Subject: Material for today's Light-duty GHG NPRM discussion.

Summary points from EPA review of CAFE model (NPRM version) – Effect of EPA code revisions

Meeting with Office of Management and Budget/OIRA

Growth in Fleet Size Due to Scrappage Model

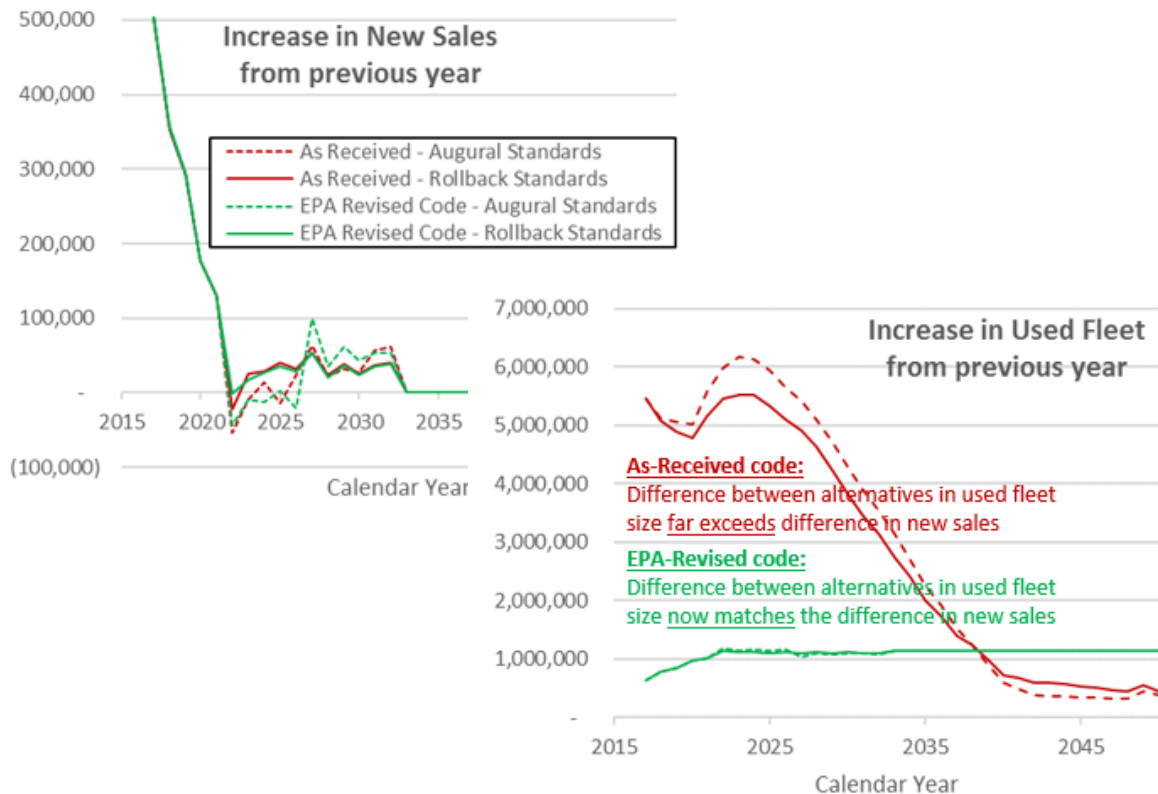
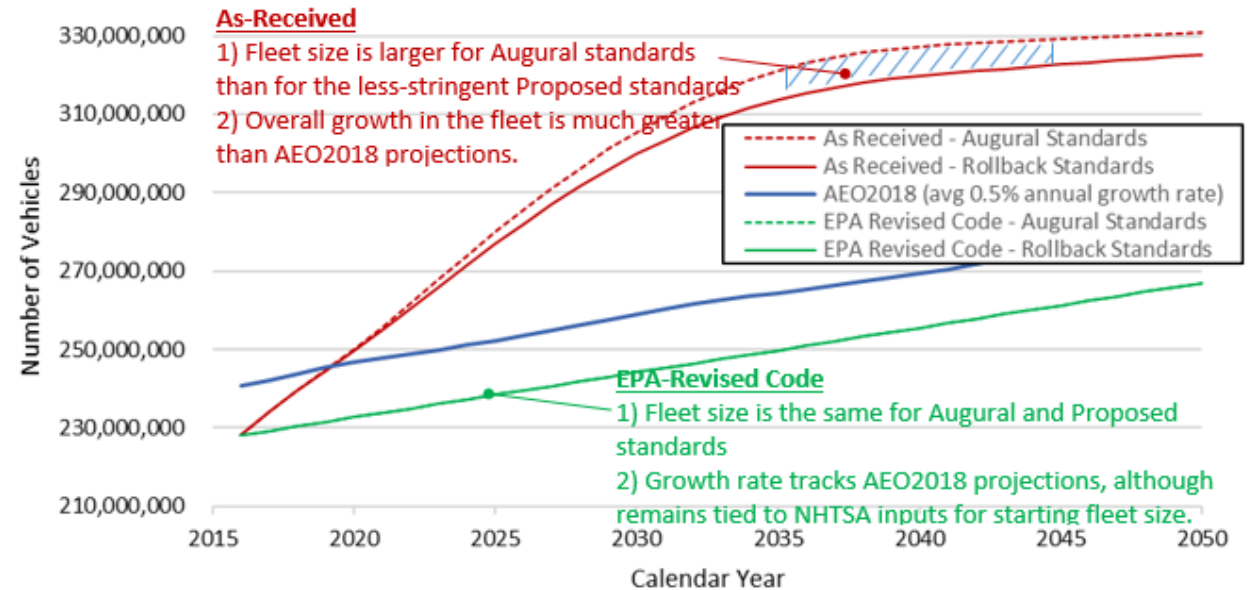
The new vehicle sales model produces small reductions in projected sales under the Augural standards, while the scrappage model projects an increase in fleet size that far outweighs the sales reductions (by a factor of 60:1.) The combined result is a fleet size that grows much more rapidly than AEO projections.

Specific the overall fleet growth as an input, and scale the scrappage rate curves (maintain the new sales model as is)

Growth in VMT beyond the intended rebound-related increase

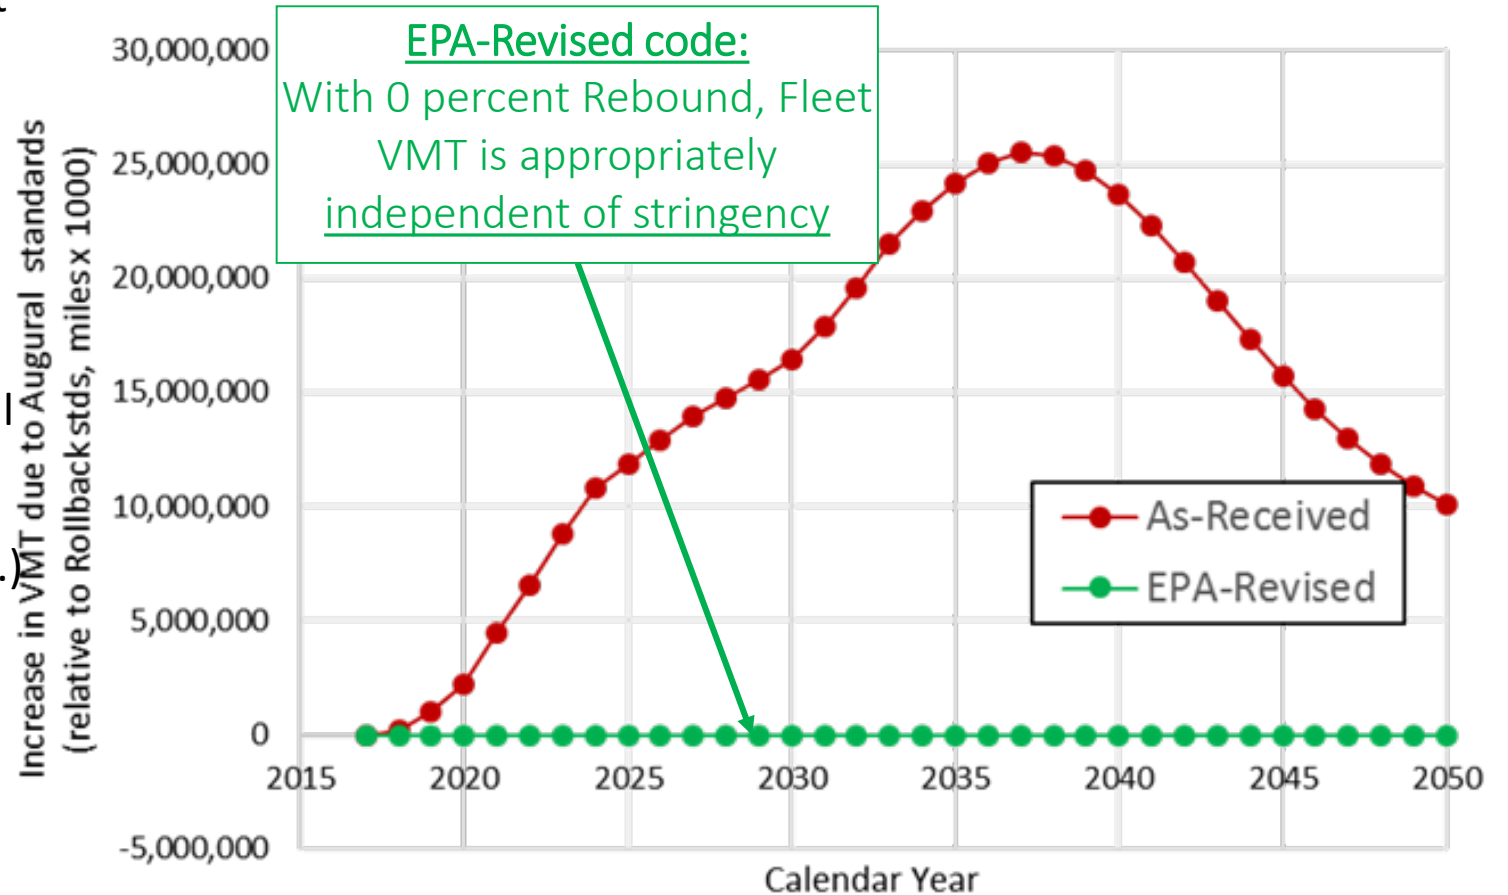
Per-vehicle VMT schedules are fixed, and not dependent on the scrappage model. As a result, total VMT can vary in an unexpected/unintended ways (e.g., VMT changes with zero rebound, zero rebound growth more expensive new and used vehicles.)

Scale per-vehicle VMT schedules so that total VMT is consistent with definition of rebound (i.e. Total VMT remains constant across regulatory alternatives at 0 percent rebound.)

MY2030 Required and Achieved CO2 levels for Each manufacturer regulatory car and truck fleets

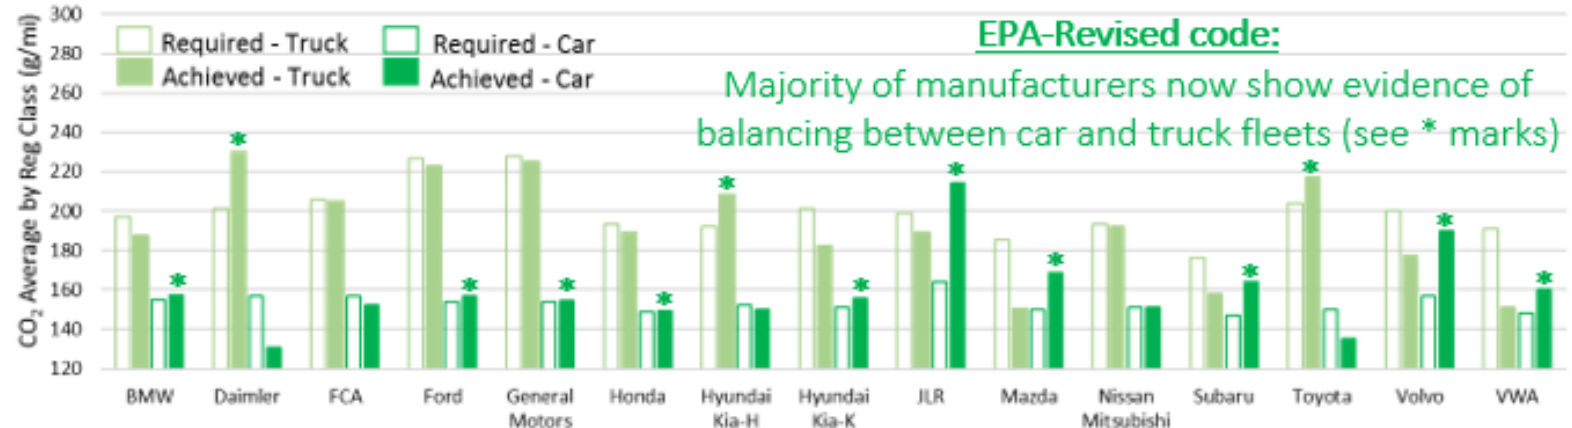
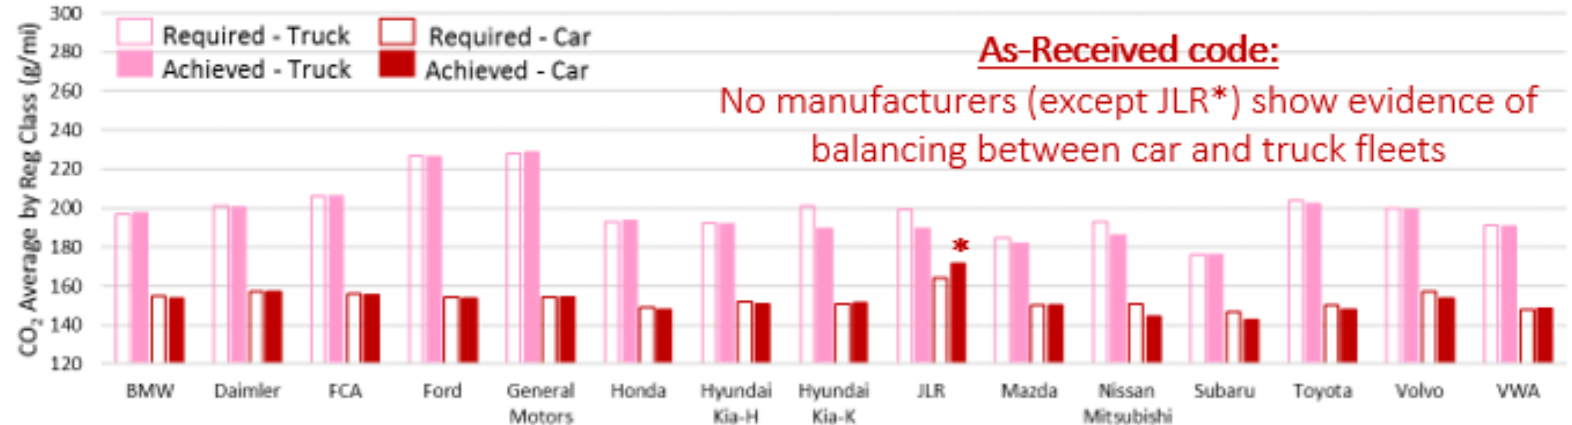
Model logic for determining manufacturer compliance status inhibits fleet averaging (car-truck trading)

- Changed the manufacturer compliance status determination so that a positive sum of car and truck fleet credits will be appropriately considered as 'in compliance.' The results show broad transfer of credits between car and truck fleets, as would be expected.

Figure 2 Year-over-year increase in new vehicle sales (left) and increase in used fleet size (right) using As-Received CAFE model (note the difference in y-axis scale)

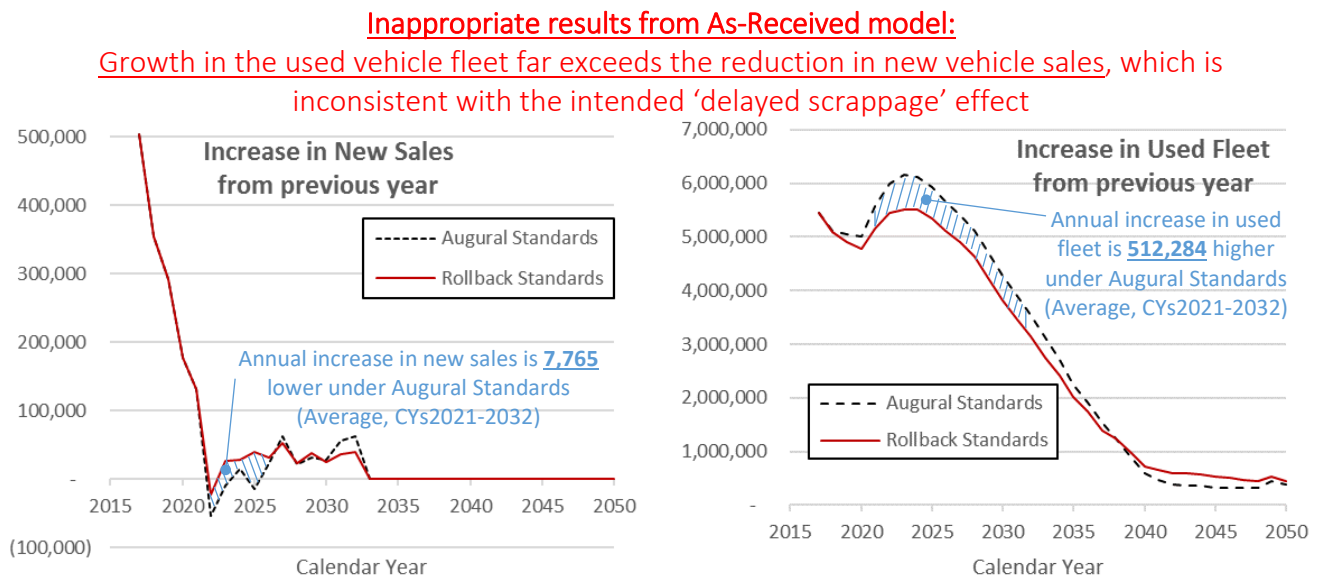
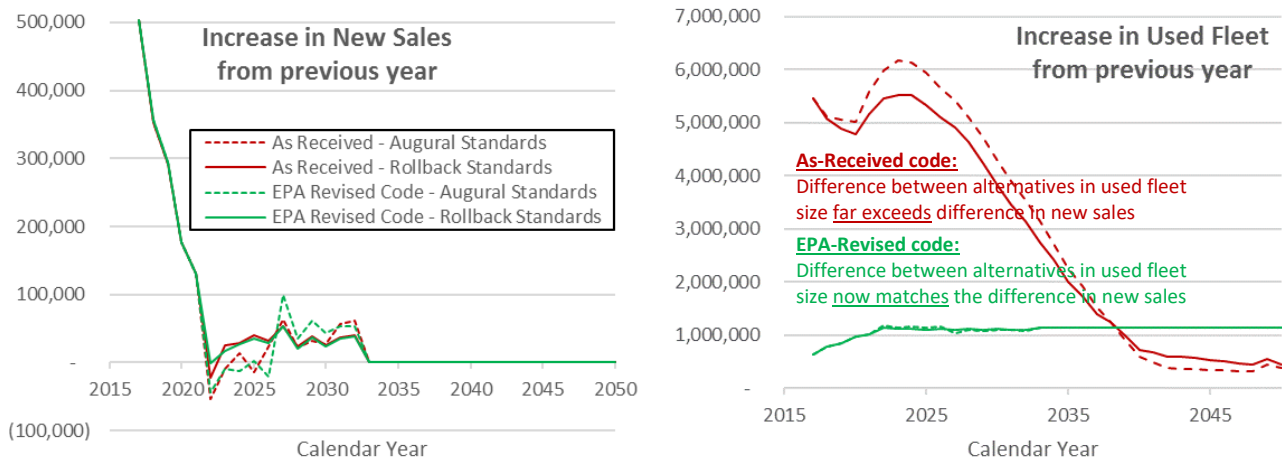
The effect of the disconnect between the new sales and scrappage models in the As-Received version is illustrated in Figure 2. Both the new sales fleet (i.e. vehicles of age 0) and the used fleet (i.e. vehicles of age greater than 0) generally increase year-over-year in the Augural and Proposed cases. For the used fleet, this is an expected trend since new vehicle prices and GDP increase for both the Augural and

While directionally those trends are logical, the difference in the magnitude of impact the Augural standards have on the new sales and scrappage models is difficult to justify. The As-Received model estimates that the Augural standards will reduce the year-over-year annual increase sales of new vehicles by approximately 8,000 vehicles on average between CY2021 and CY2032. However, during the same period, the As-Received model estimates that the used fleet will grow by an average of 512,000 vehicles per year, far exceeding the decrease in new vehicle sales. It’s hard to imagine any real-world scenario under which over 60 additional used vehicles are retained for each new vehicle that the sales model predicts will be unsold as a result of the higher new vehicle prices.

EPA modified the CAFE model to align with the NHTSA’s stated intent, so that the scrappage model predicts fleet composition, but does not dictate total fleet size. Our modified code allows the user to select a fleet growth rate (we have used the AEO value of 0.5% growth per year by default, but other rates could be used.) Our code then allows the model to run as usual to determine new vehicle sales and the composition of the used vehicle fleet. These values are then used to scale the size of the used vehicle fleet (maintaining the predicted composition) to achieve the user-provided growth in fleet size. This way the new vehicle sales are identical to the As-Received values, the used vehicle fleet has the identical composition as the As-Received values, but the fleet size grows at much more reasonable rates.

Figure 3 Total fleet size in As-Received CAFE model (AEO 2018 0.5% growth rate shown for reference)

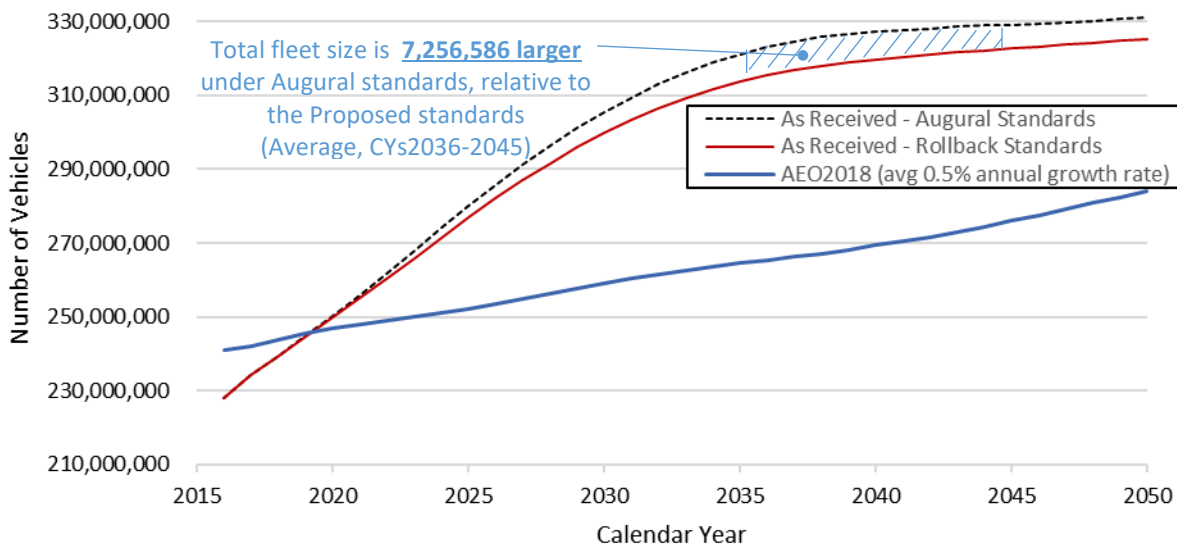
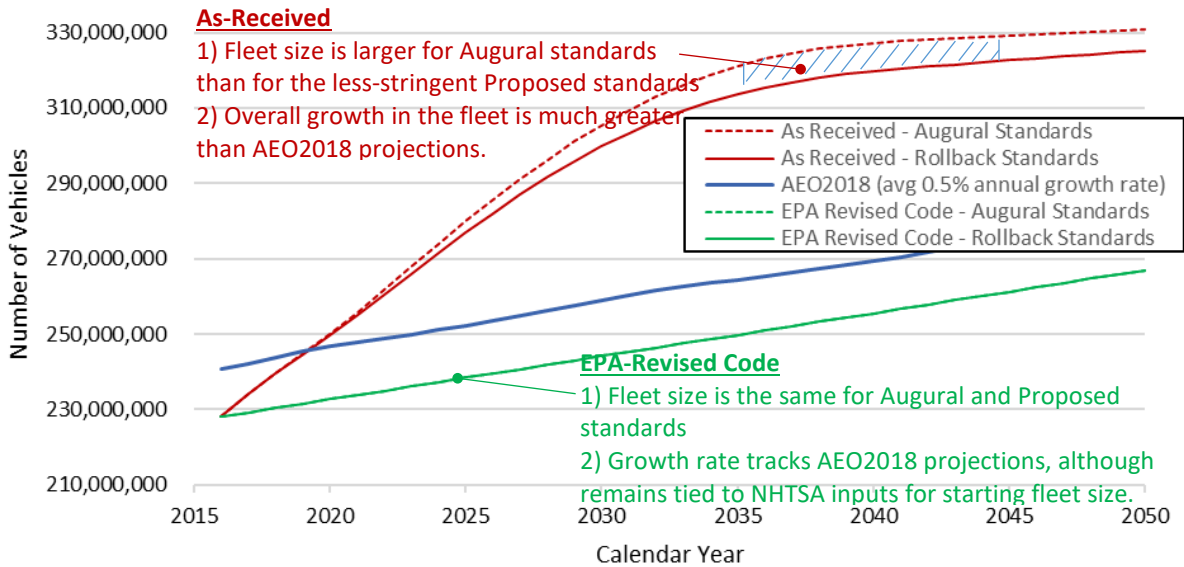
Figure 3 shows the combined effect of the new vehicle sales model and the scrappage model in the As-Received version of the CAFE model. A change in the overall fleet size due to the Augural standards might not in and of itself be problematic, as long as the VMT schedules are adjusted to account for overall travel activity that is distributed over a larger number of vehicles. However, the As-Received version of the model does not adjust VMT schedules, with the result that the additional unscrapped vehicles inflate total VMT proportionately. During the period over which the summary statistics for fatalities are reported in the draft NPRM (CYs 2036-2045), the difference in the estimated fleet sizes between the Augural and Proposed standards is approximately 7 million vehicles, or over 2% of the

Total Fleet size grows with increases in stringency and cost of new and used vehicles, which is not consistent with the basic principle of supply and demand

Figure 4 Change in VMT due to 20 percent rebound with As-Received model, Proposed standards case (change shown is relative to 0 percent rebound)

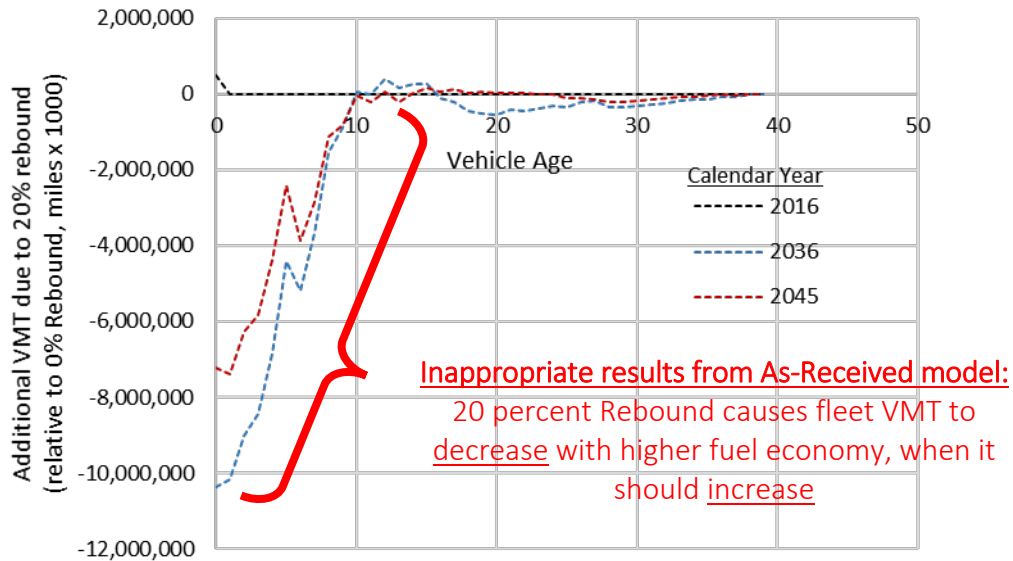
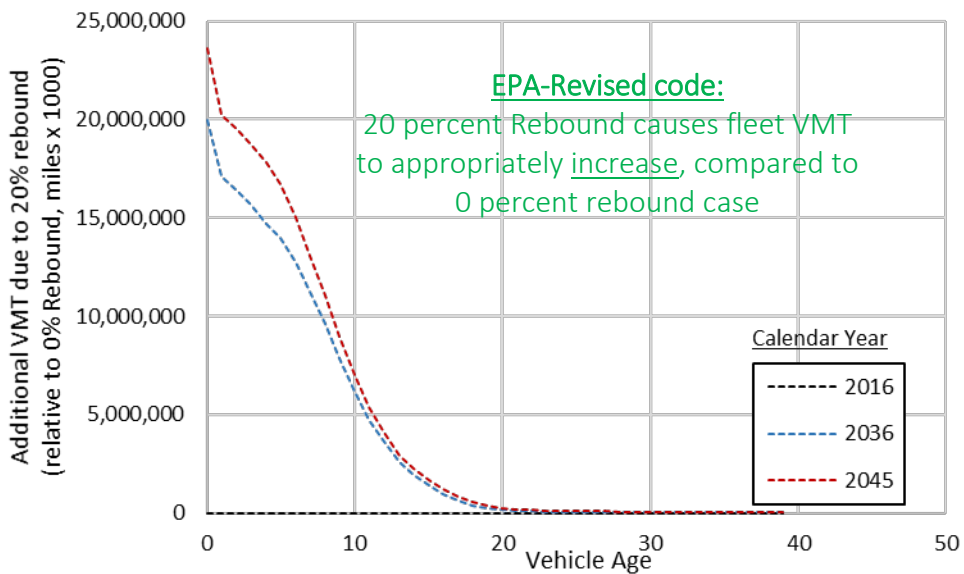
One of the problems with the implementation of the rebound calculations in the code of the As-Received model is illustrated in Figure 4 for the Proposed standards. In this case, the inclusion of 20 percent rebound causes a reduction in VMT in future calendar years, despite the fact the Proposed standards produce a fleet with higher fuel economy and lower cost per mile than the baseline (MY2016) fleet. This result is clearly inappropriate, since by definition the rebound effect should result in more miles driven as cost per mile decreases.

After reviewing the CAFE model code, we have determined that the directionally incorrect reduction in total fleet VMT with 20 percent rebound shown in Figure 4 and Figure 5 above is due to the combined effect of two problematic assumptions used for calculating the reference cost per mile (CPMref) in Equation 1. The first assumption is the use of a constant CY2016 fuel price to calculate CPMref, even as CPMnew is calculated using the future year’s fuel price. The consequence of using two fuel prices that diverge further with each year (due to future projected increases in fuel prices) is that VMT calculated from Equation 2 becomes lower over time, independent of any changes in fuel economy. Such a result is unjustified since it ignores the economic and income growth that is projected to occur concurrently with fuel price increases.

We believe that the most defensible implementation of the rebound effect is one that maintains the same CPMrate over every calendar year in the course of a vehicle lifespan. In the example shown by the green line in Figure 7, the CPMrate for the MY2025 vehicle then becomes simply a function of the ratio of the reference fuel economy to the new fuel economy and the 20 percent rebound effect value, or $[(1 / 1.1) - 1] * (-0.2) = 0.0182$. To achieve this, we revised the CAFE model code so that:

Figure 5 CPMrate variation by vehicle age and fuel economy improvements during redesign of 10 percent (left panel) and 50 percent (right panel)

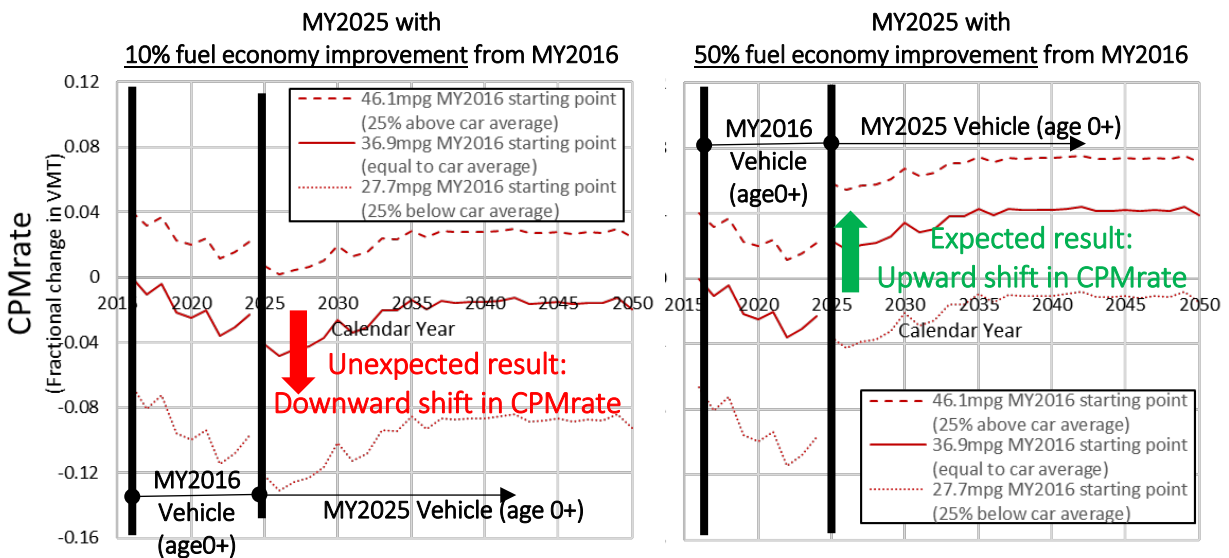
Figure 5 gives a closer view of the CPMrates determined from Equation 1 for three example vehicles, with MY2016 versions which maintain a constant fuel economy at levels equal to, 25 percent above, and 25 percent below an average MY2016 car.⁹ These values are maintained until a MY2025 redesign, when the fuel economy is improved by either 10 percent (left panel) or 50 percent (right panel) compared to the MY2016 versions.

One notable observation is how the CPMrates vary by calendar year as the individual vehicles age. This is unexpected, since the CPMrate is applied to the annual mileage values that already account for the progressive decline in the miles driven each year as vehicles age. What the age- or year-related phenomenon this variation in CPMrate would be intended to represent is not clear. Another notable observation is the inconsistency in the direction of change in CPMrate of the new MY2025 vehicle, relative to the 8-year old MY2016 vehicle in CY2024. When the MY2025 vehicle is 50 percent more fuel efficient than MY2016 (right panel of Figure 5), the CPMrate shifts upward, resulting in higher VMT for the vehicle with greater fuel economy as would be expected. However, when the MY2025 vehicle is only 10 percent more fuel efficient than MY2016 (left panel of Figure 5), the CPMrate shifts downward. This tendency to produce VMT reductions for newer vehicles with moderate levels of fuel economy improvement is consistent with the inappropriate VMT results shown in Figure 4 above, indicating that this issue is caused by the calculation of CPMrate within the CAFE model.
